ORIGINATION FORM

Proposed Revisions to a Standard Plans Index
(Please provide all information — Incomplete forms will be returned)

Index Number: 715-001
Sheet Number (s): 1 OF 3
Index Title: Conventional Lighting

CONVENTIONAL LIGHTING

WIRING DIAGRAM

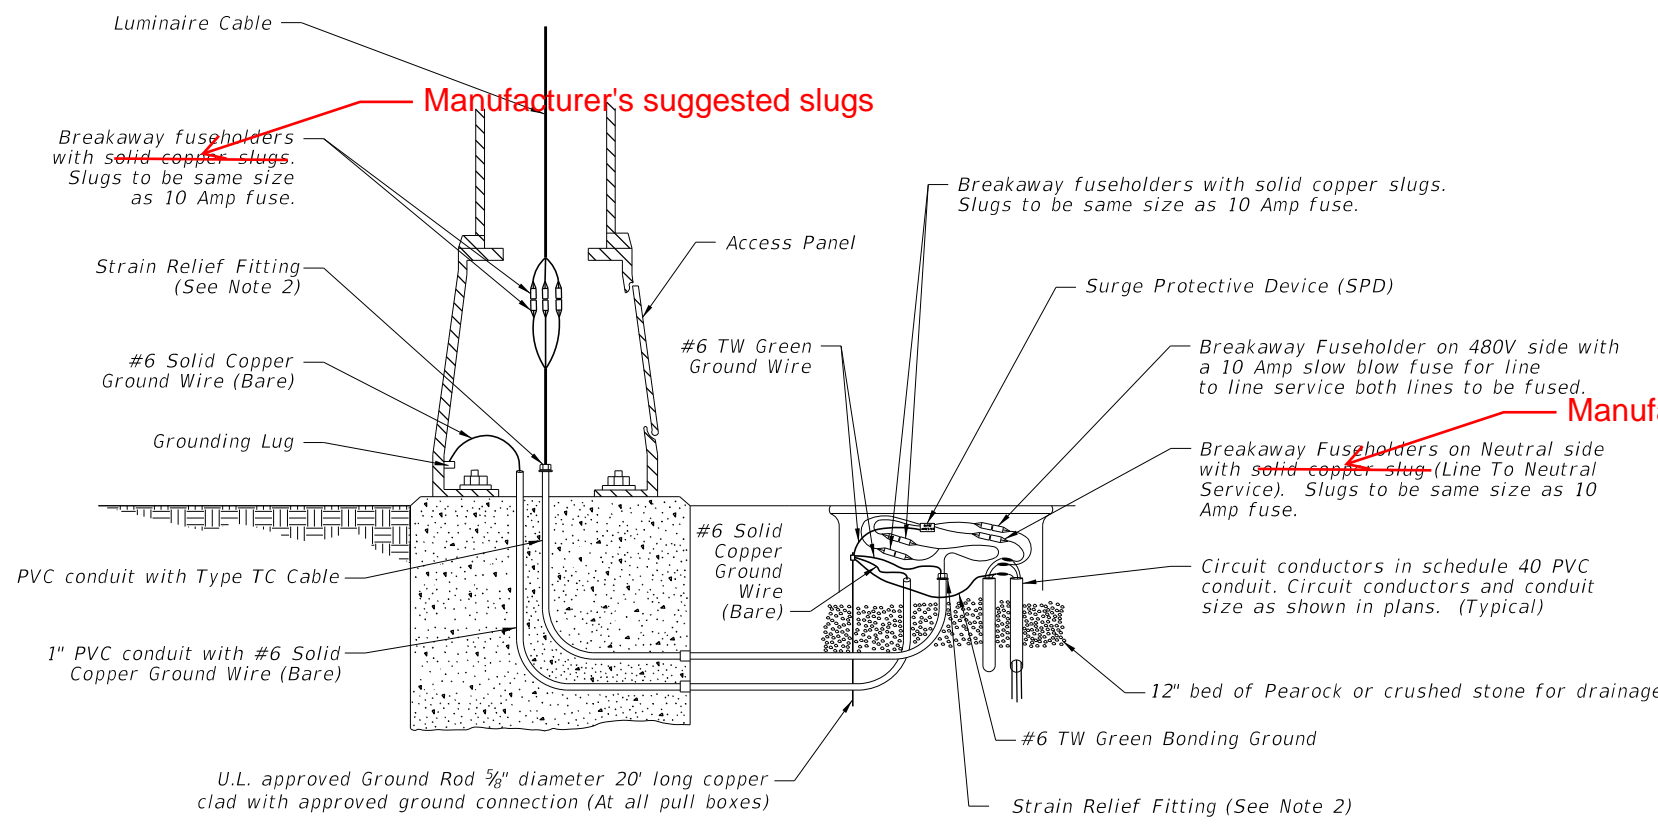
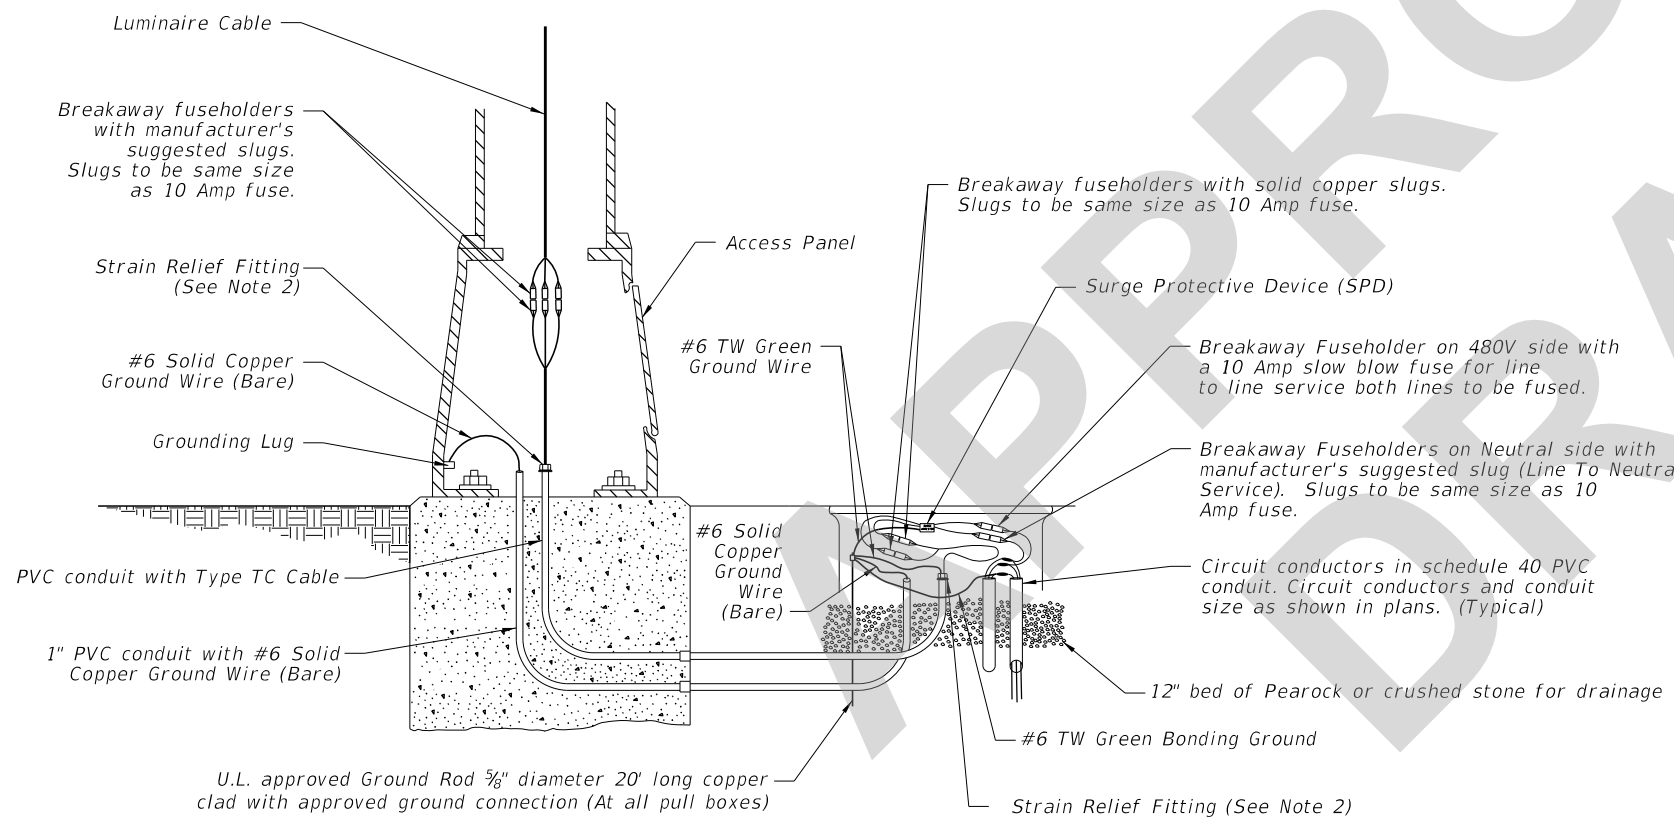
Sheet 1: Changed fuse holder slug (blank) requirement from solid copper to manufacturer's suggested in three drawing locations.

Manufacturer's suggested slug

Industry advised that solid copper slug requirement is impractical and uncommon. Specification 992 is being revised to require the fuse holder manufacturer's suggested slug of copper equivalent (manufacturer generally responsible for performance of their product). This Standards change reflects the Specifications change.

METAL POLE WIRING DETAIL

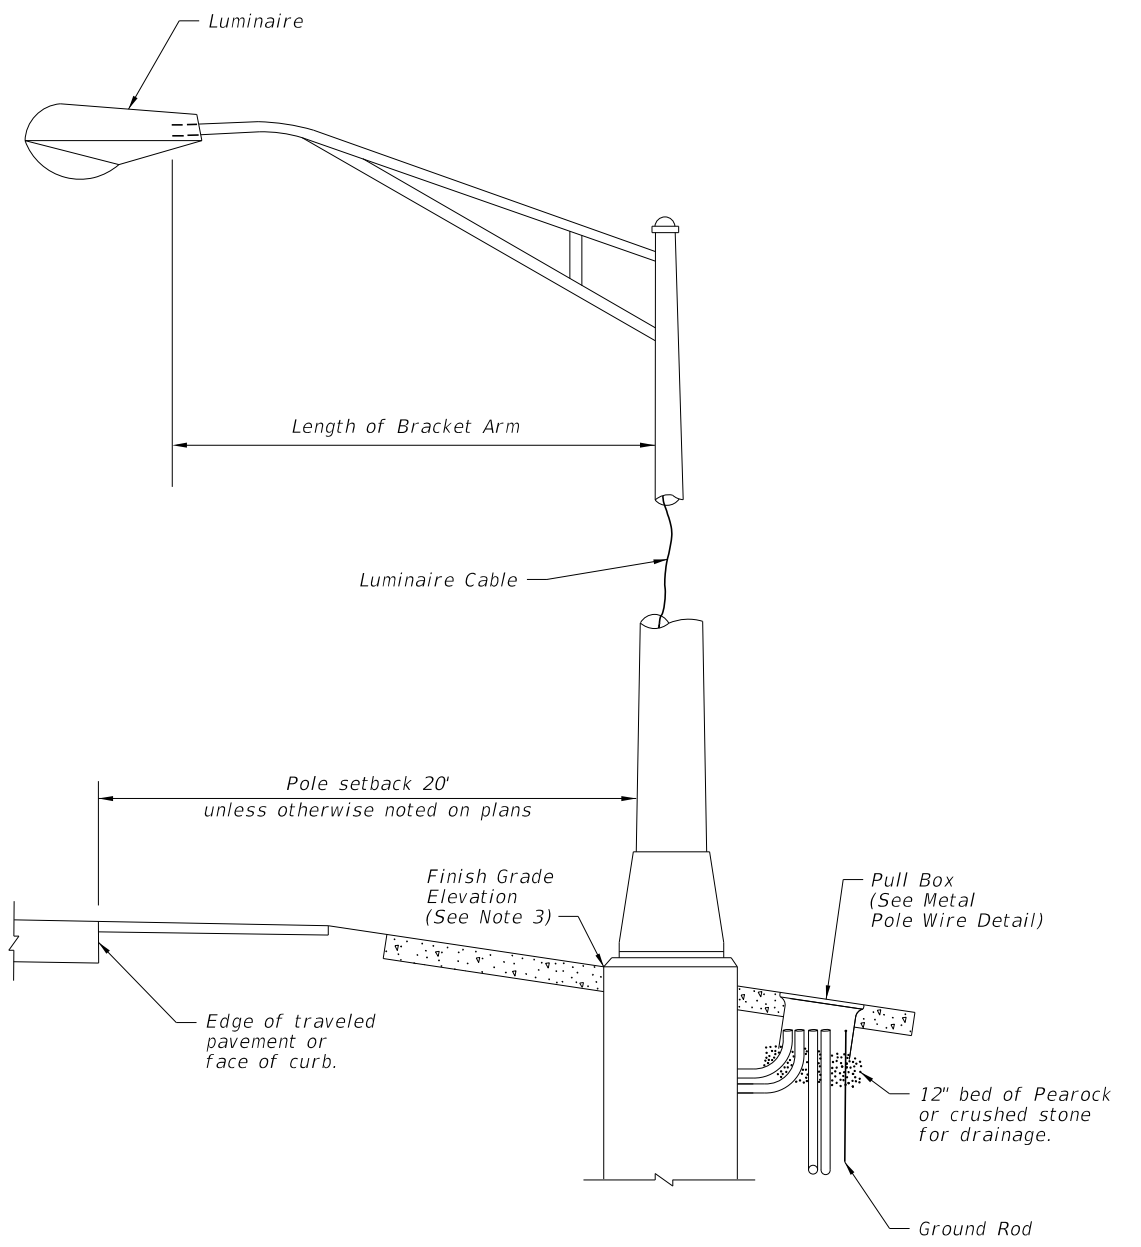
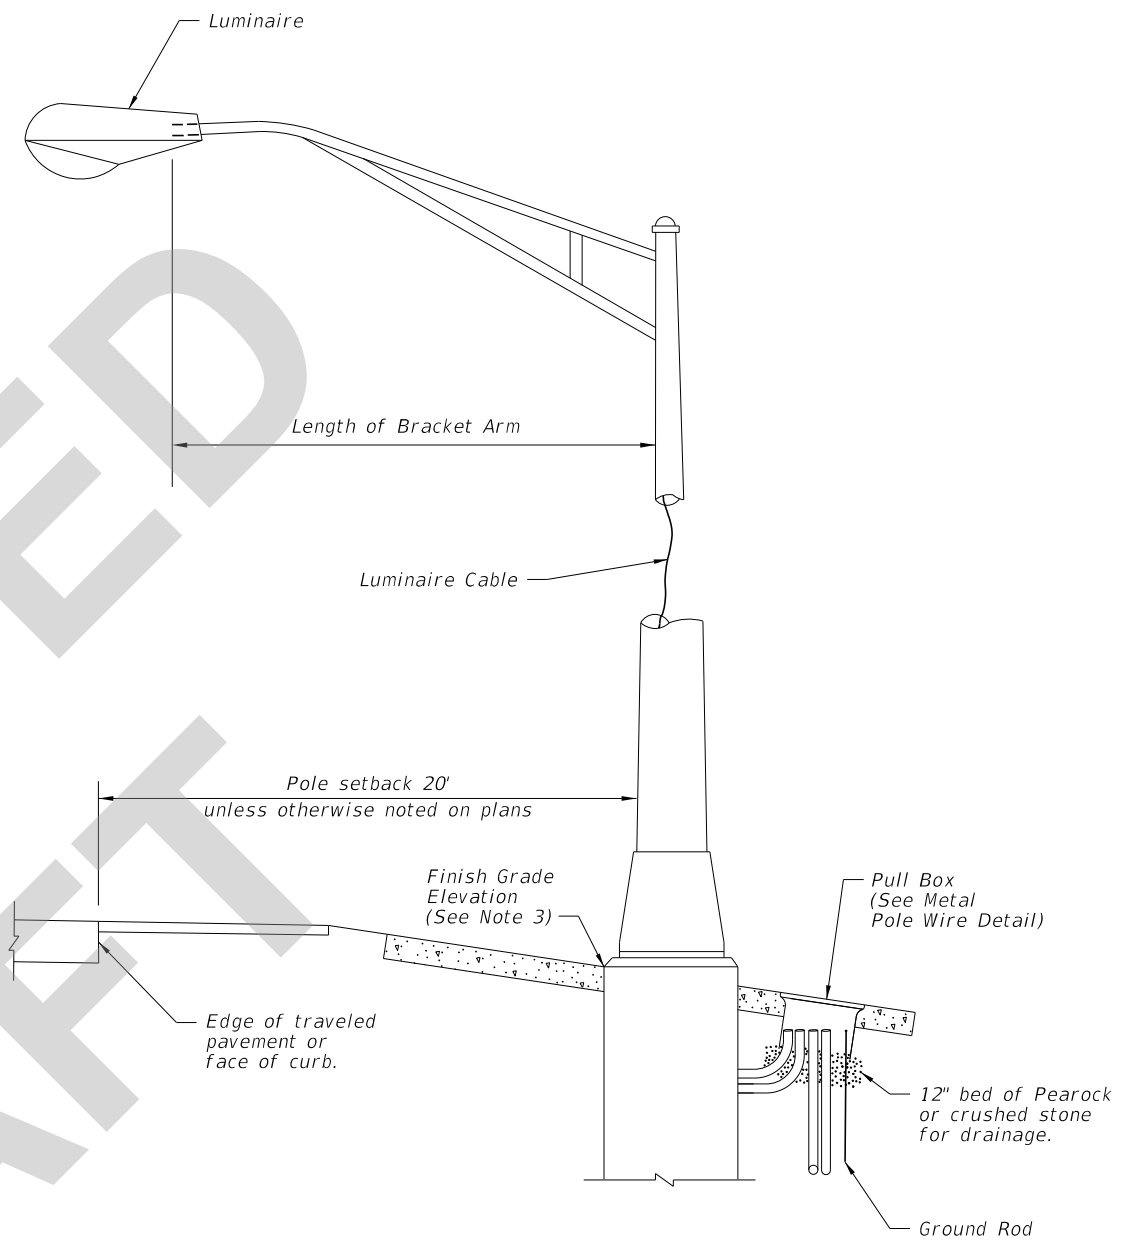
Manufacturer's suggested slugs

Manufacturer's suggested slug
